UNITED STATES  
NUCLEAR REGULATORY COMMISSION  
WASHINGTON, D. C. 20555  
July 11, 1985

Docket No. 50-416

LICENSEE: Mississippi Power and Light Company  
FACILITY: Grand Gulf Unit 1  
SUBJECT: SUMMARY OF JUNE 19, 1985 MEETING REGARDING CONTAINMENT  
SUPPRESSION POOL SWELL THROUGH ENCROACHED AREAS

The purpose of the meeting was to discuss resolution of concerns regarding containment suppression pool swell through encroached areas. Enclosure 1 is a list of attendees. Enclosure 2 is a copy of slides and/or handouts prepared by an NRC consultant used in the meeting. Enclosure 3 is a copy of slides prepared by General Electric (GE) used in the meeting.

TABLE 1: POOL SWELL IN 1/10-SCALE SIMULATION  
OF UNENCROACHED POOL (FROM FIGS. 1-5)

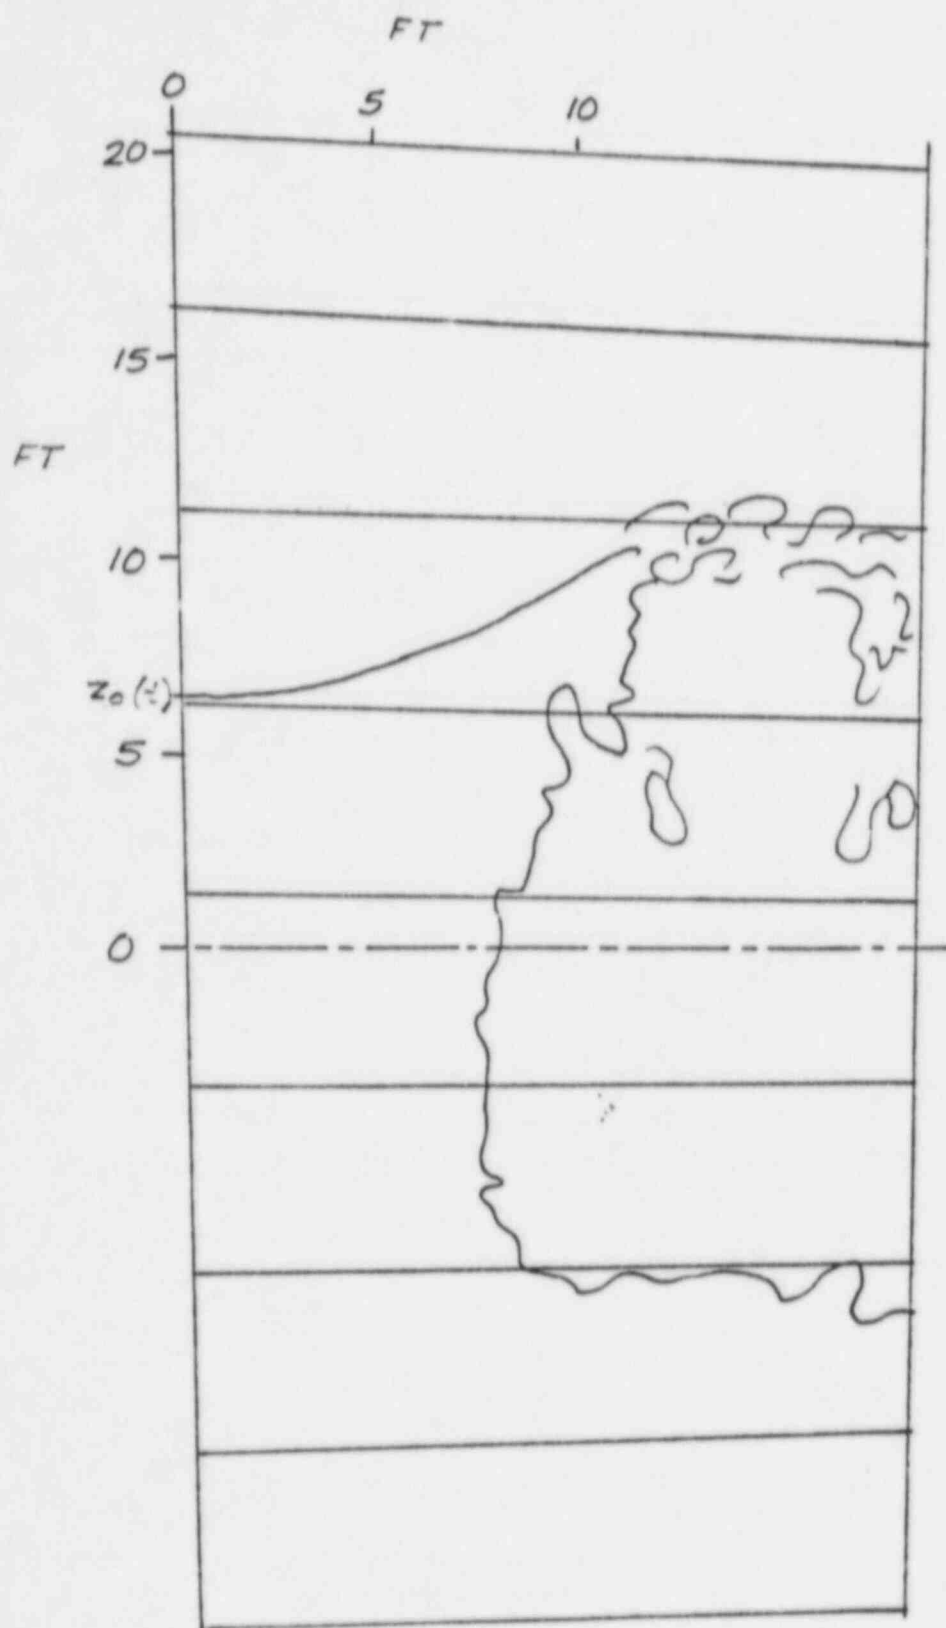
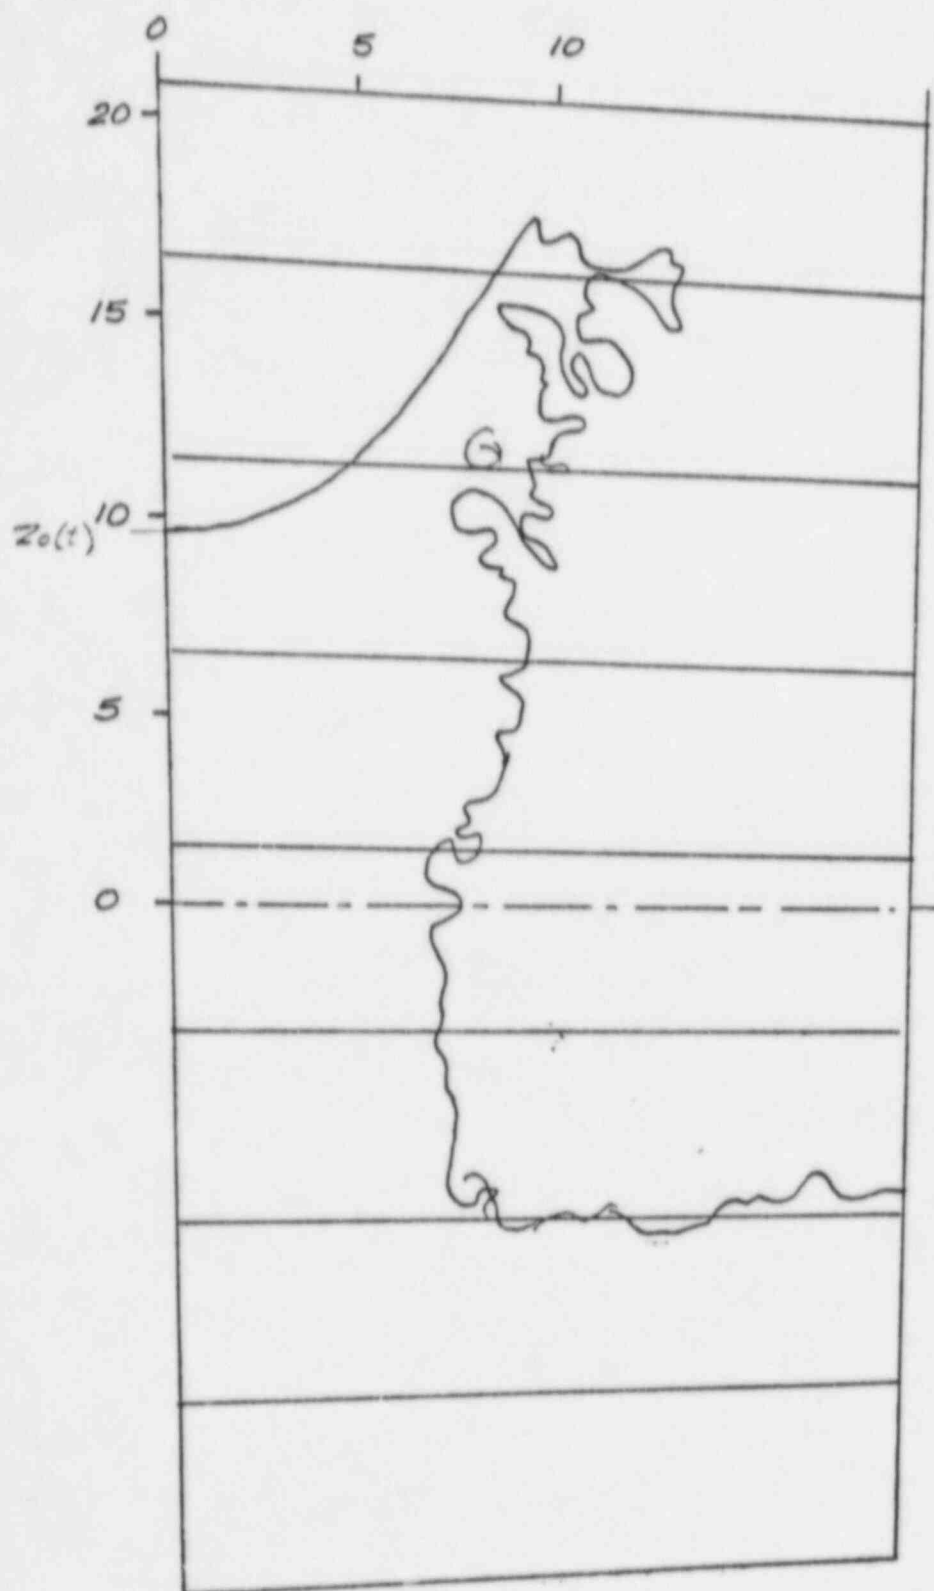
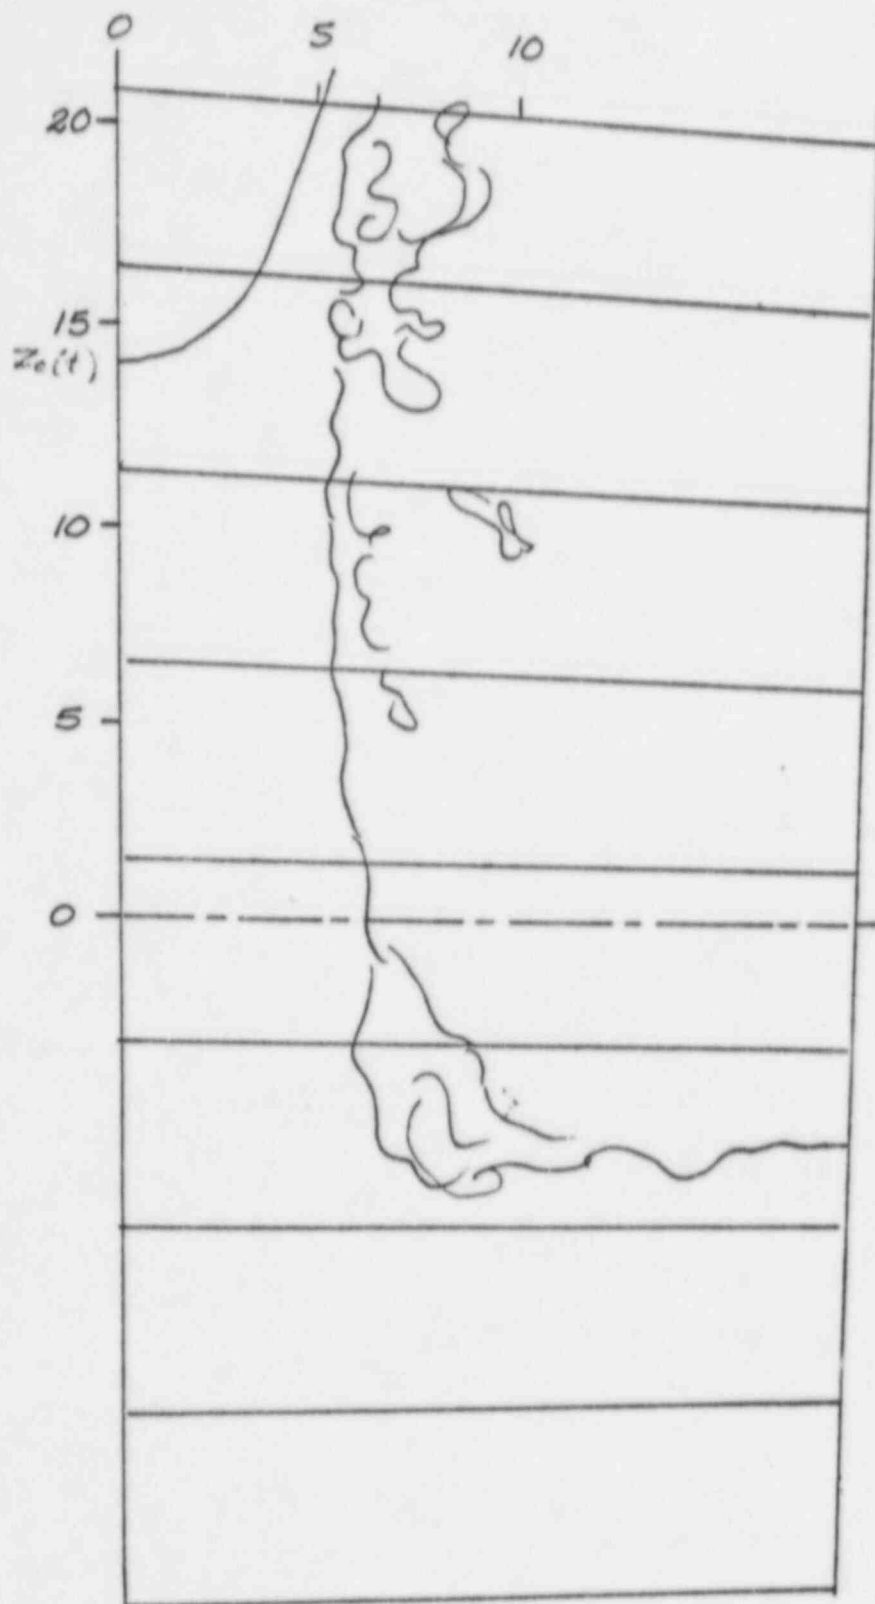
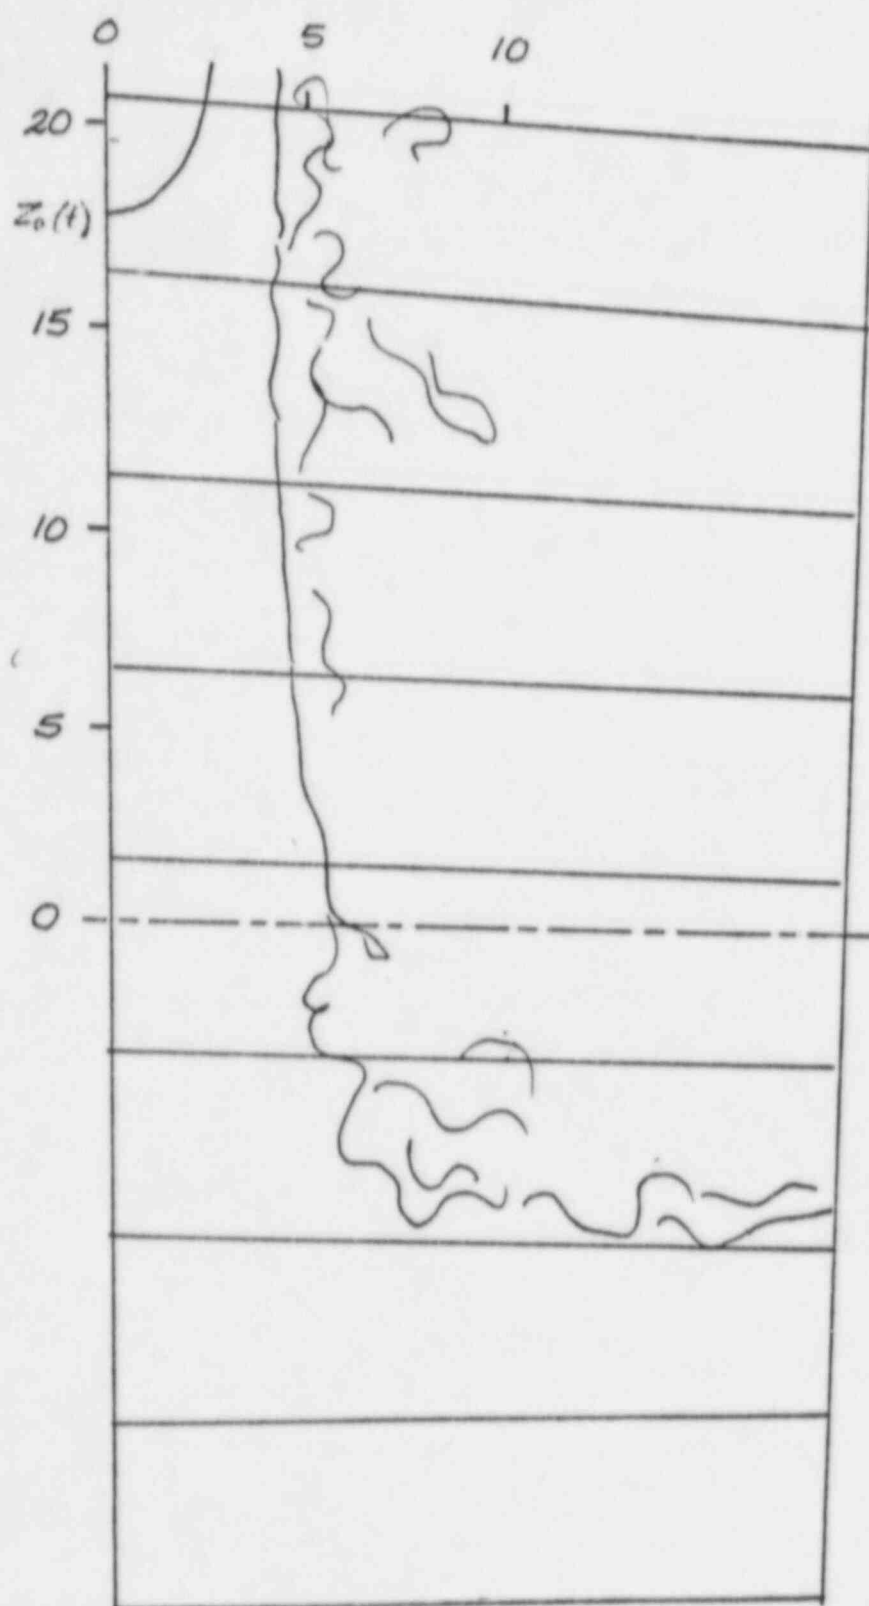
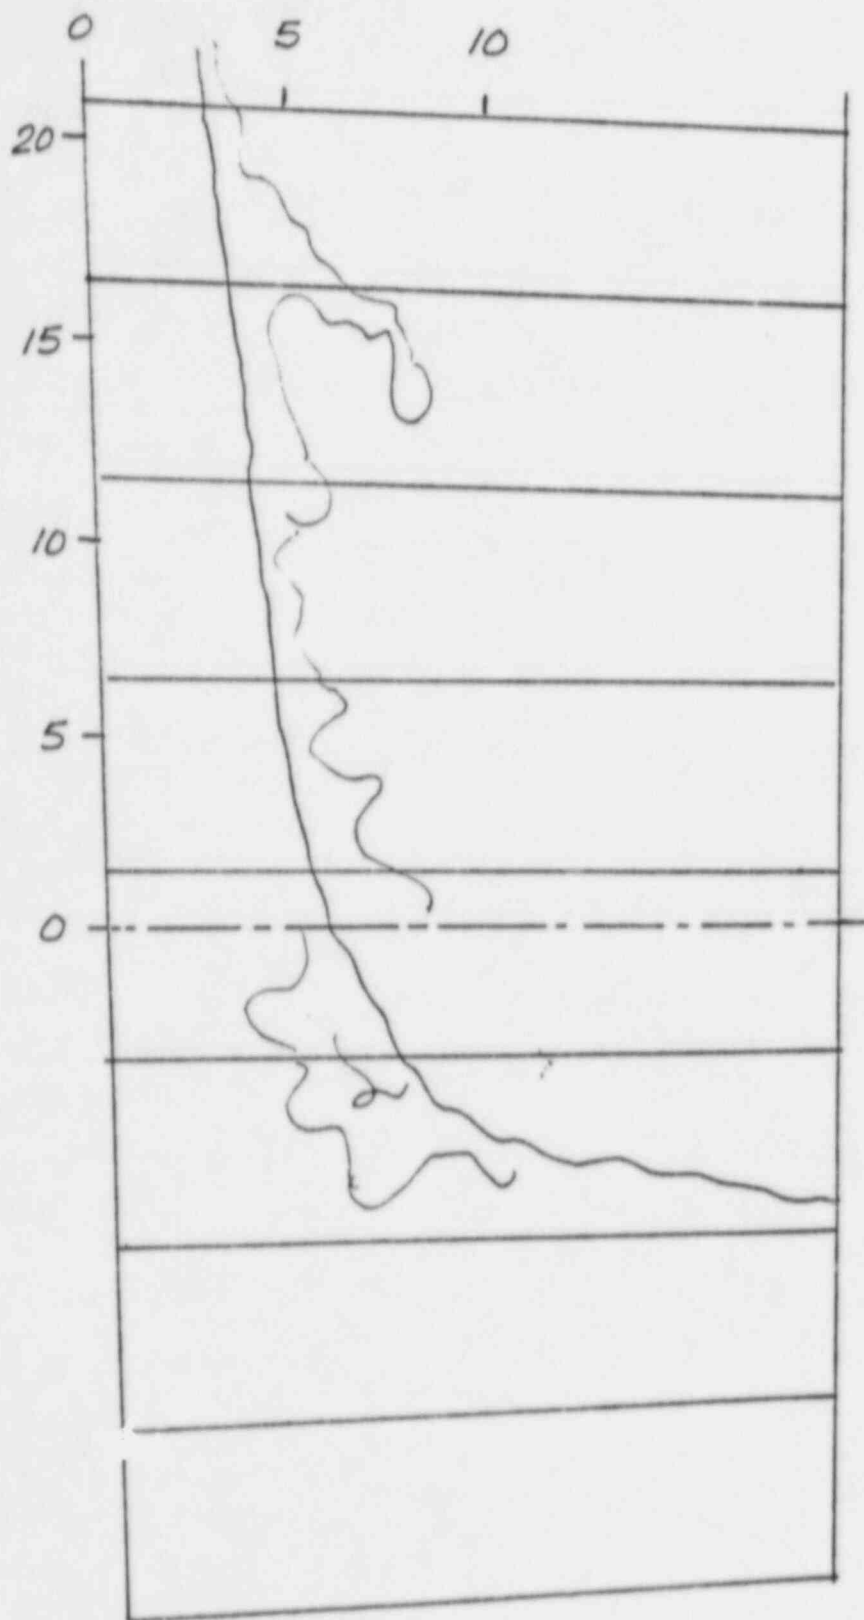
1. In both the unencroached and the various encroached pools, a 4-5 foot wide stream of solid water rose along the containment wall and reached the HCU floor level with high velocity.

The existing LD recognizes only "froth" above 18-19 FT.

Concern: Impact loads at HCU floor level.

2. Velocities higher than 50 ft/s were observed in the solid water stream in the unencroached pool and some of the encroached pools.

Concern: impact/drag loads on structures below HCU floor in region traversed by water stream.

Based on  $1/10$ -scale data, examine regions where solid-water stream has  $V > 50 \text{ ft/s}$ , and revise LD accordingly for structures (if any) in those regions.

Fig. 6 Run 5801-9 water ligament 0.57s after vent clearing (full scale time). Distances are indicated in full scale feet. Data from NEDM-13407 P.  $1/\sqrt{3}$  - scale Moody-scaled test.

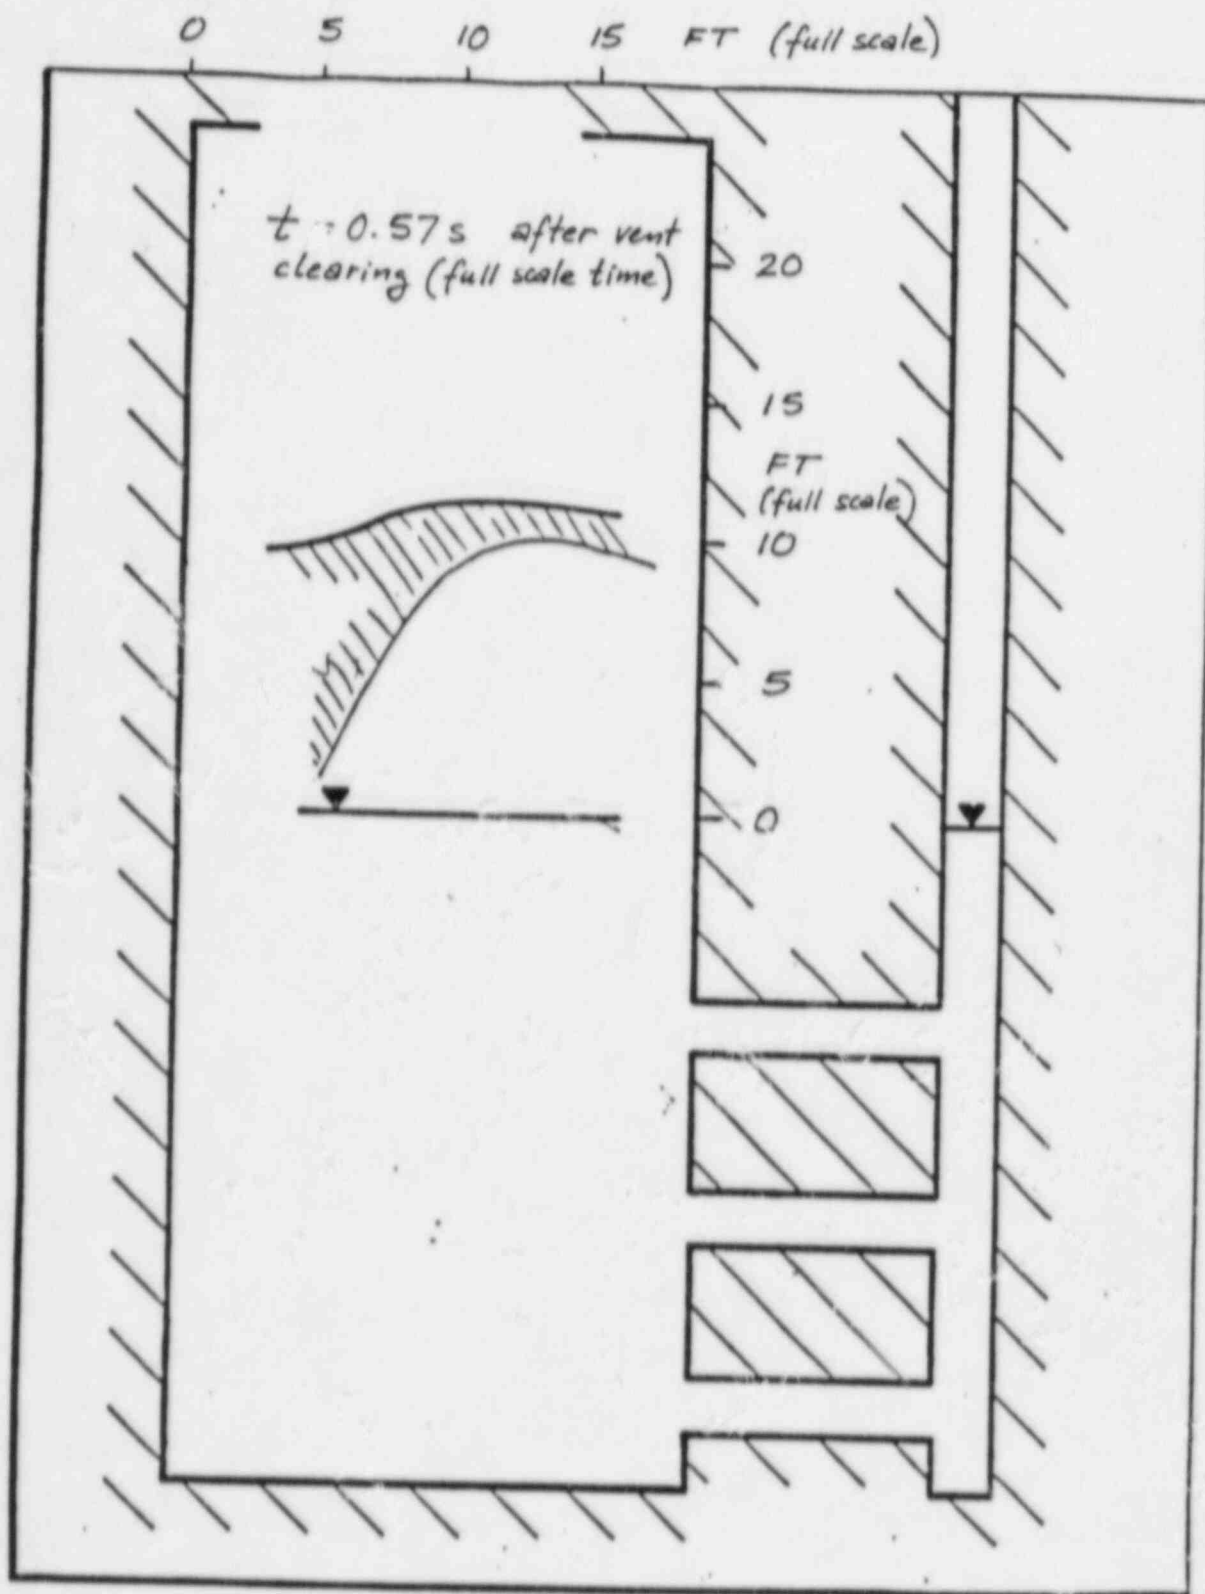
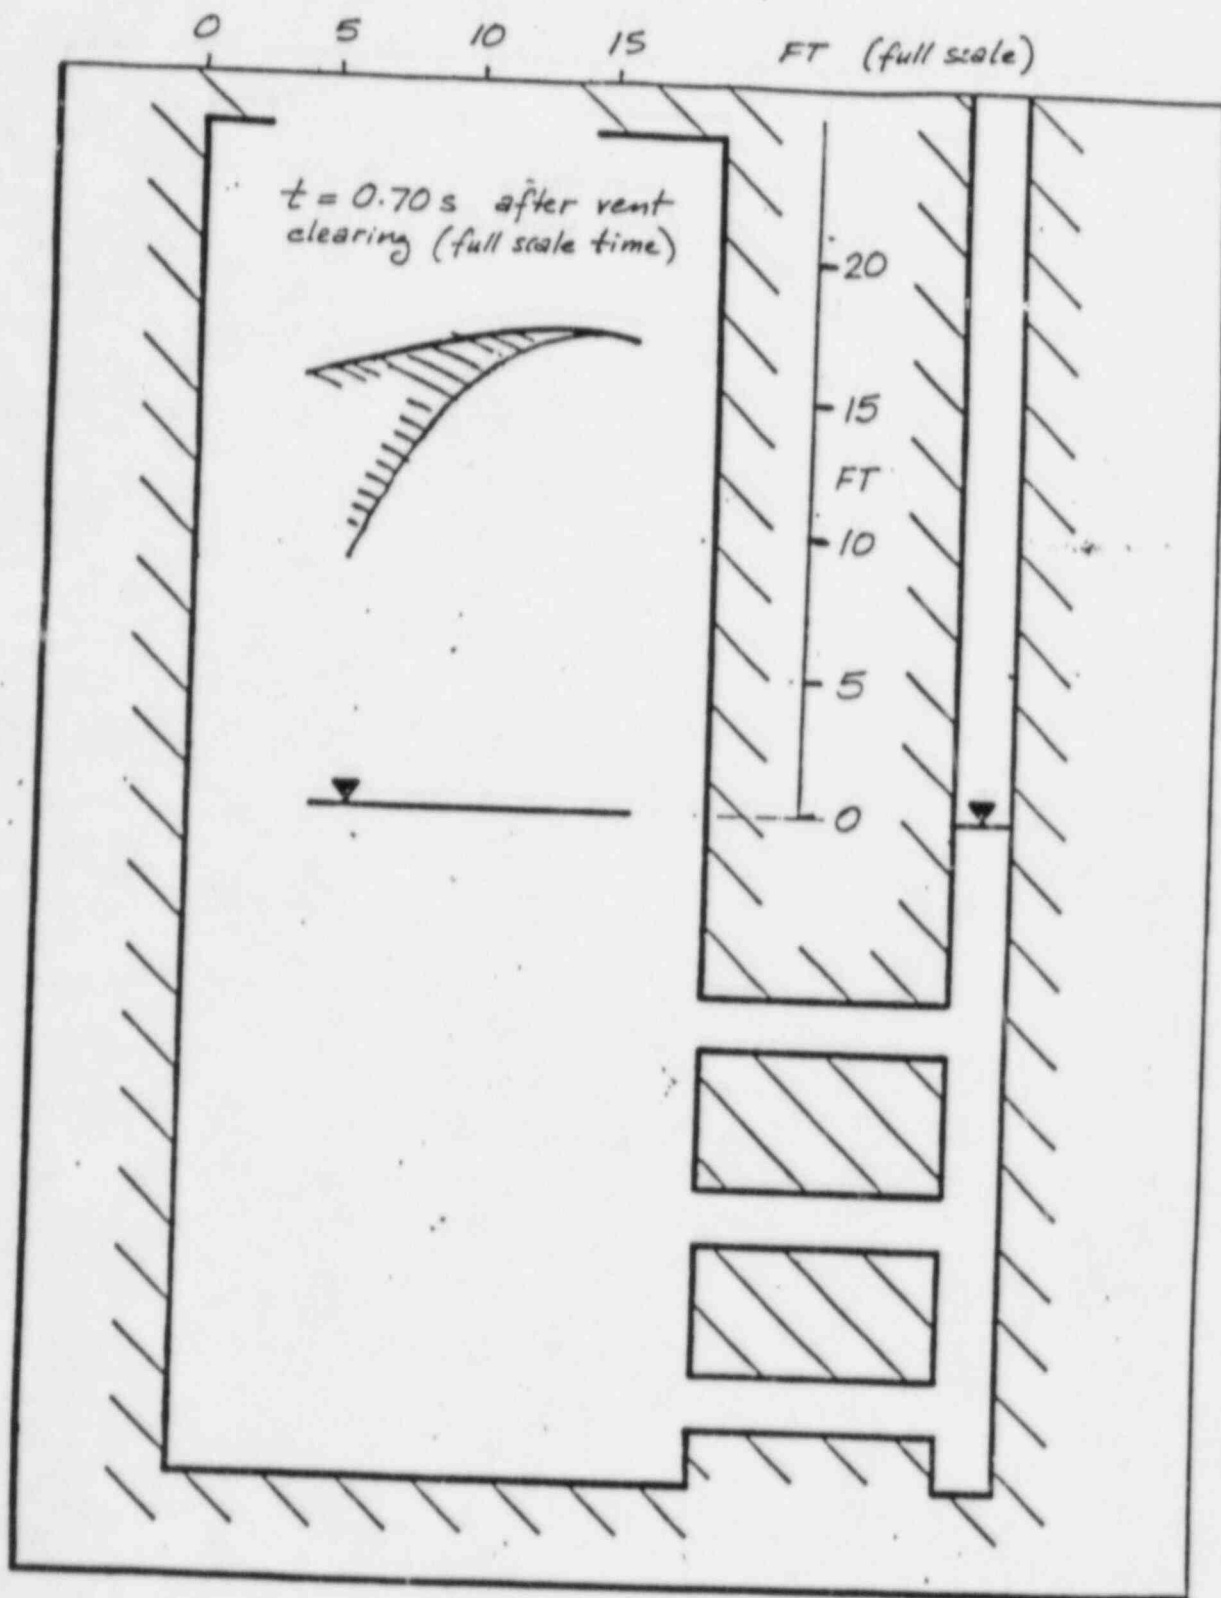
- The existing LD is based on  $1/\sqrt{3}$ -scale expt's where stream should have been present and water velocities properly simulated. Also, measurements were made in the region where the stream was subsequently found.
- Hence, existing LD should be OK!
